TECHNICAL INFORMATION COMMUNICATION

Number: TIC2017-0009 Date: 12/14/2017

Title: Improvements for Horizontal Right "A" Coil Applications

Product Category: Furnace Coils

Figure 1

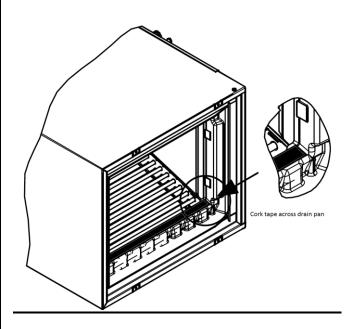
- 1. The carton includes a strip of cork tape. The cork tape is used to create an air seal between the undersides of the pan extension and in front of the vertical drain pan. See Figure 1.
- 2. Horizontal Right Installation (figure below) is included to show the extension pan installed using the included self-tapping screws. See Figure 2.
